PSC Questions and Staff Responses – Better Housing by Design Proposed Draft

September 20, 2018

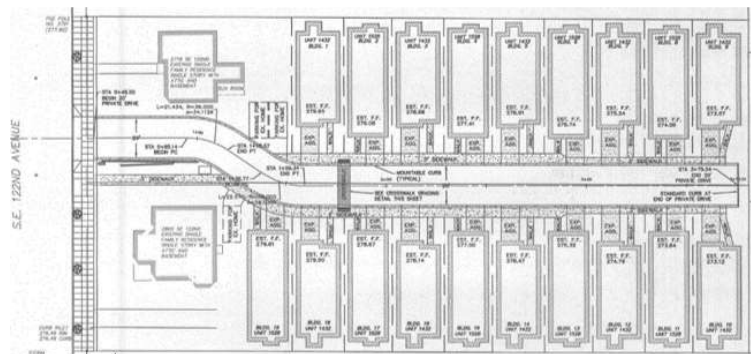
PSC Question	Staff Response												
<p>1 Historic district bonuses. Interested in differences between how bonuses and height are regulated in historic districts inside and outside the Central City.</p> <p>Percentage of Multi-Dwelling Zoning Located in Historic or Conservation Districts</p>

<p>*More than 60% of multi-dwelling acreage is in the RM1 zone</p> <p>Also see Multi-Dwelling Zones and Historic Districts Maps</p>	Zone	% and Acres	RM1	2% (70 acres)	RM2	5% (69 acres)	RM3	13% (35 acres)	RM4	41% (55 acres)	Total	4% (229 acres)*	<p>Regulations for bonus FAR and height in Historic and Conservation districts, inside and outside the Central City:</p> <ol style="list-style-type: none"> Central City Plan District FAR: Additional FAR through bonuses and transfers is allowed. Height: No bonus height. Commercial/Mixed Use Zones FAR: No additional FAR through bonuses or transfers is allowed. Height: No bonus height. Multi-Dwelling Zones (BHD proposal) FAR: Additional FAR for inclusionary housing and moderate-income 3-bedroom units is allowed. No FAR transfers are allowed into historic/conservation districts. Height: No bonus height. Through a similar rationale, the BHD proposal would not allow for 100' building height in the RM4 zone in historic/conservation districts (would be limited to the standard RM4 height of 75'). Special bonus for deeper housing affordability: Not available in historic/conservation districts. This bonus provides 100% additional FAR and 10' of additional height (in most cases, this additional FAR is not possible without allowing for additional height).
Zone	% and Acres												
RM1	2% (70 acres)												
RM2	5% (69 acres)												
RM3	13% (35 acres)												
RM4	41% (55 acres)												
Total	4% (229 acres)*
